Addendum 01

Modesto Junior College, East Campus
Football Field Press Box & Elevator
435 College Ave., Modesto, CA 95350

Date : October 16, 2026
TETER Project No.: 21-12111

Client Project No.: 26-1957
DSA File No.: 50-C1
DSA Appl. No.: 02-123619

PRESS BOX EAST ELEVATION

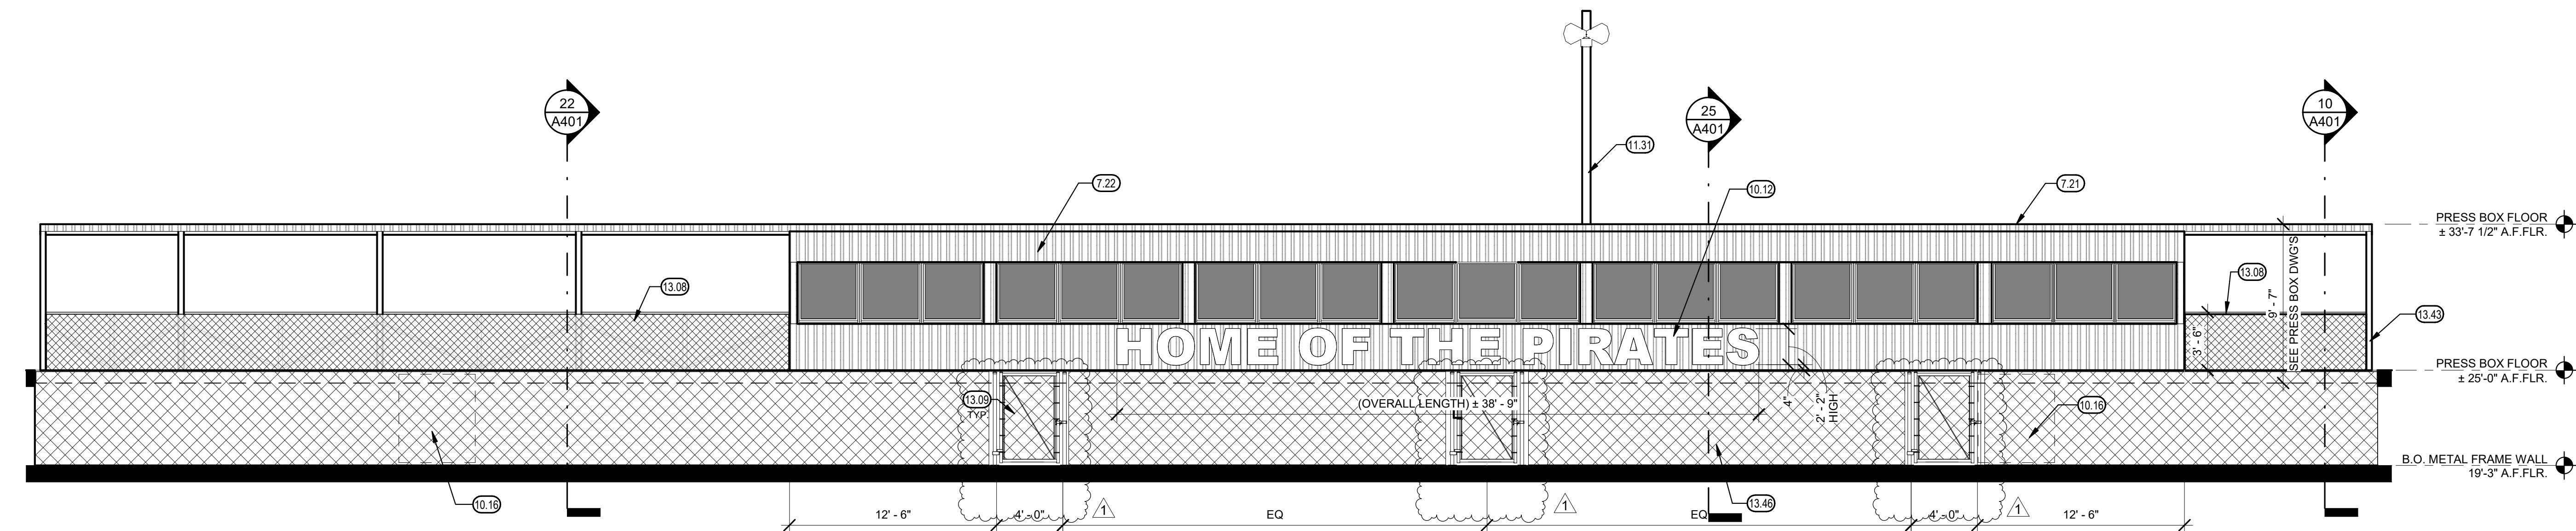
A. DETAIL 10/A303 – “PRESS BOX EAST ELEVATION”, Provide service gate assemblies per keynote 13.09 (See attachment **AD01-A01 – A303**)

DRAWING TITLE
EXTERIOR ELEVATIONS - SOUTH BLEACHERS

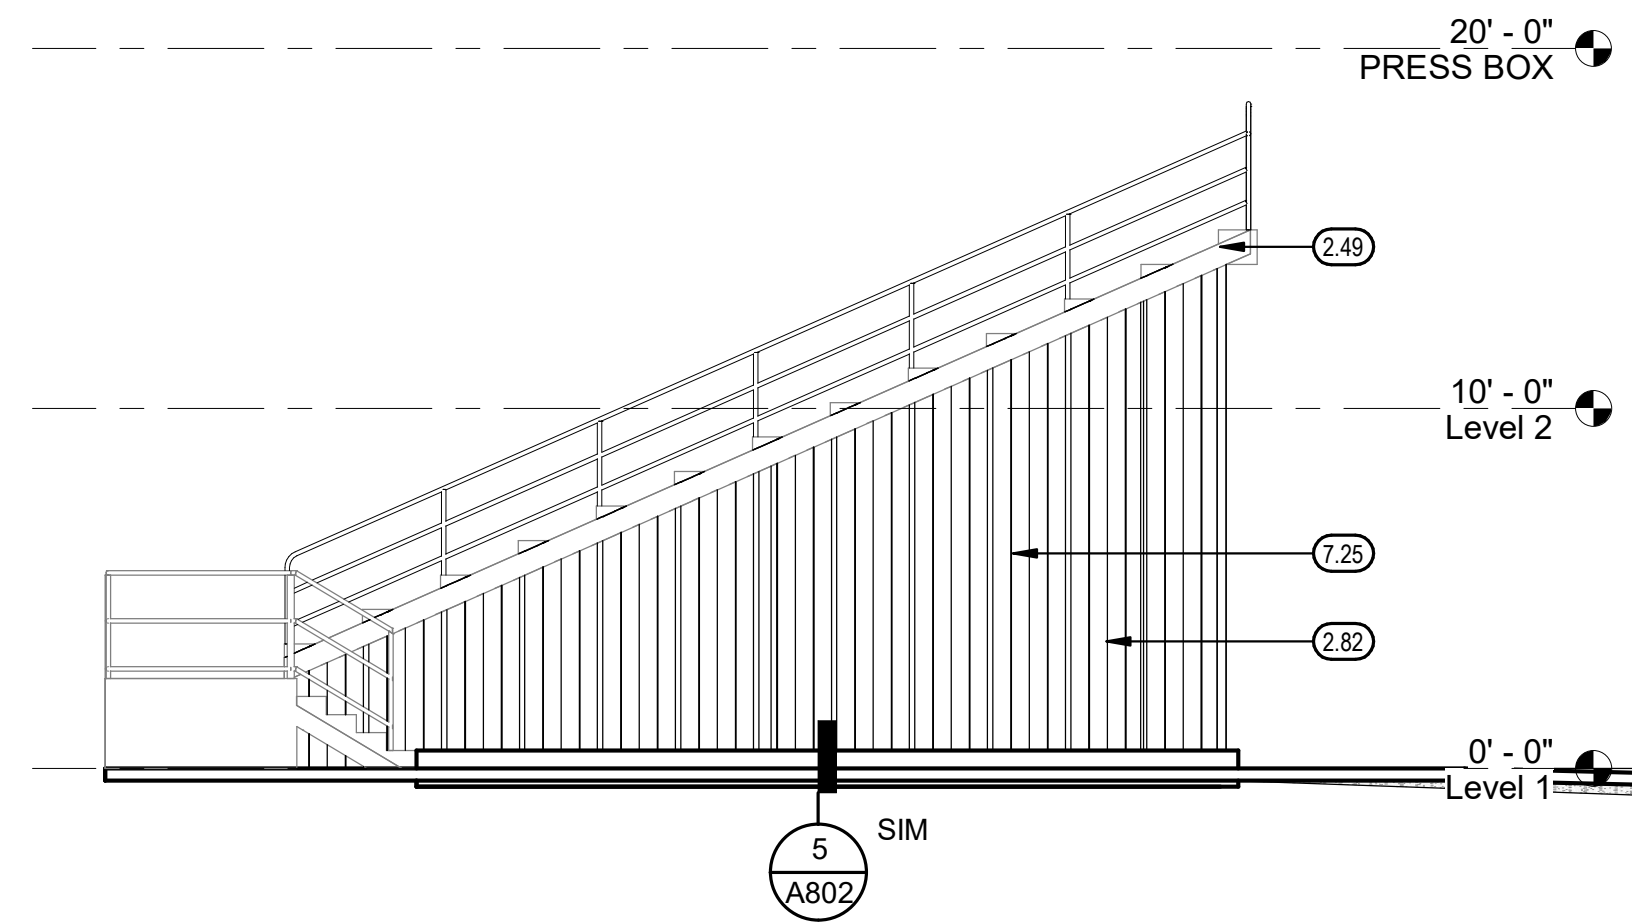
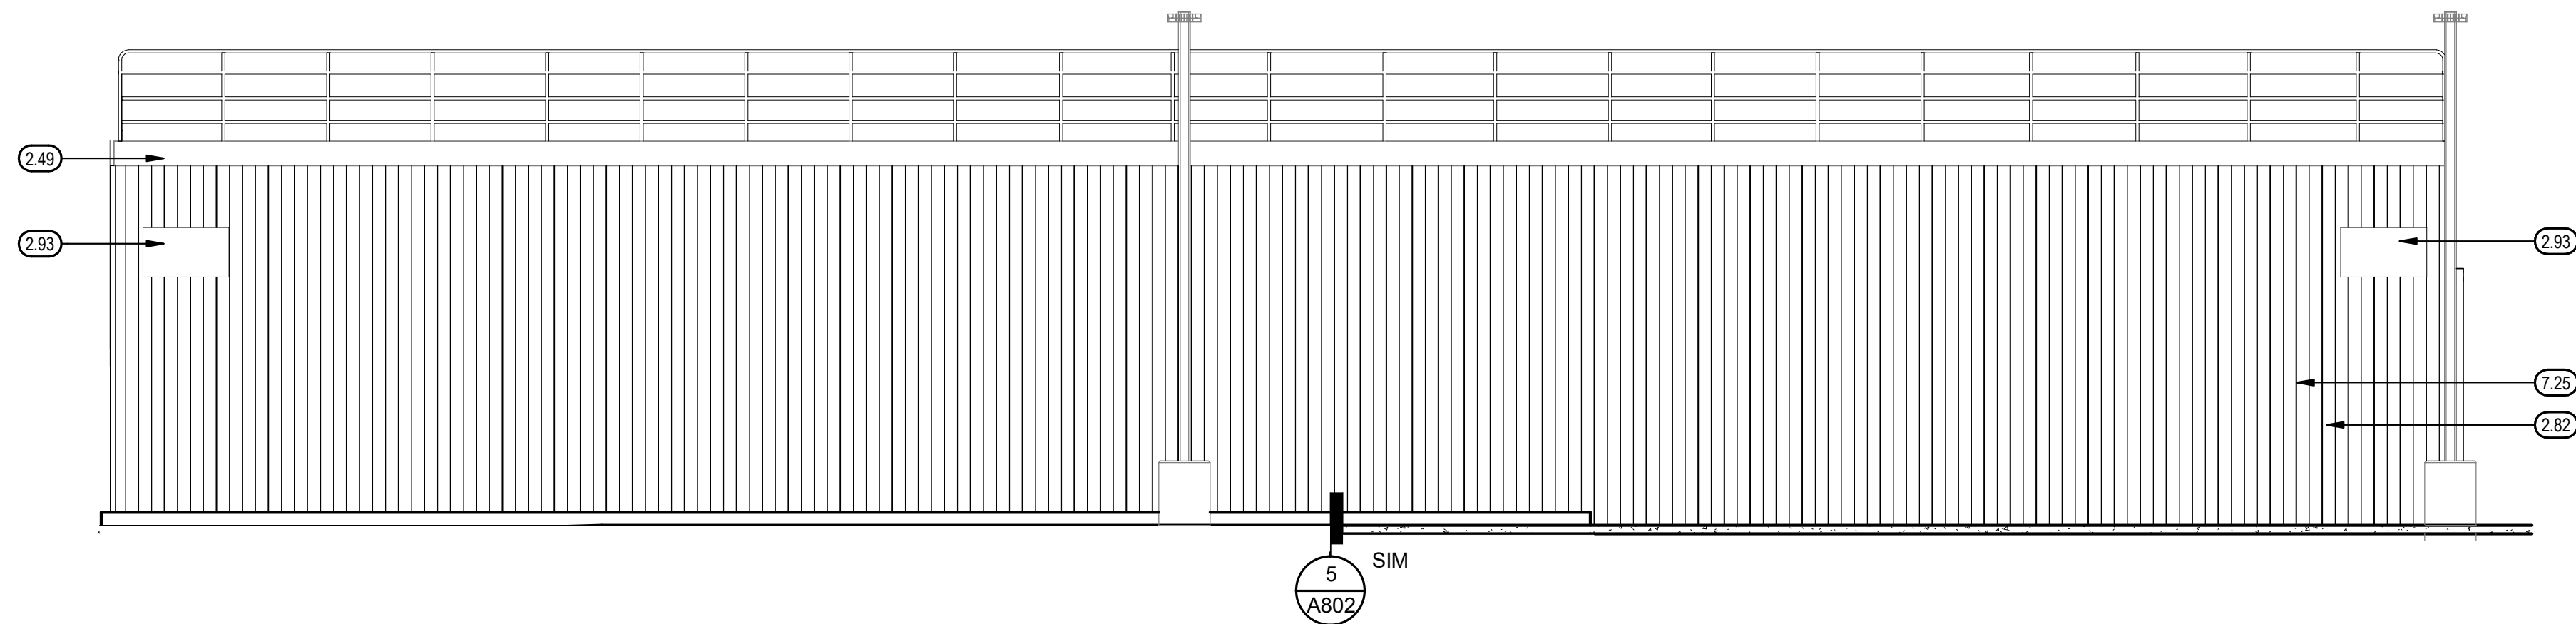
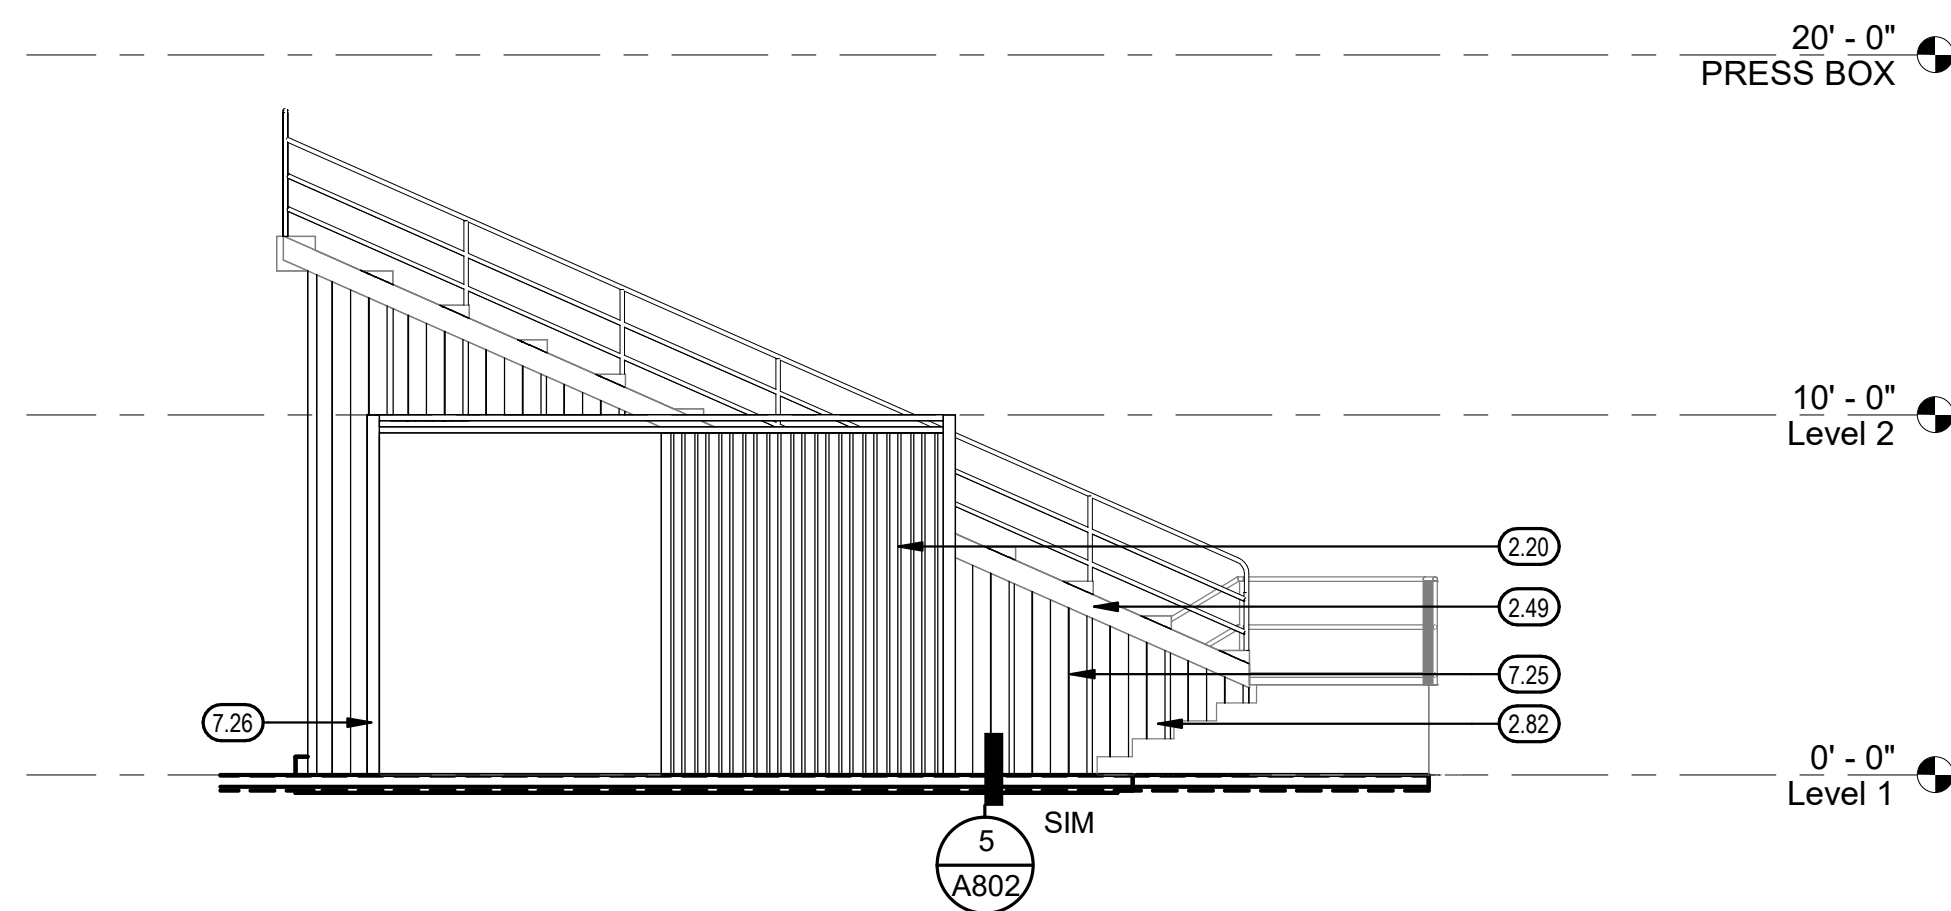
1 - 018: PROJECT DRAWINGS, SHEET A304 – “EXTERIOR ELEVATIONS – SOUTH BLEACHERS” revise as follows:

A. Add drawing Sheet “A304 – EXTERIOR ELEVATIONS – SOUTH BLEACHERS” to the PROJECT DRAWINGS (See attachment **AD01-A02 – A304**)
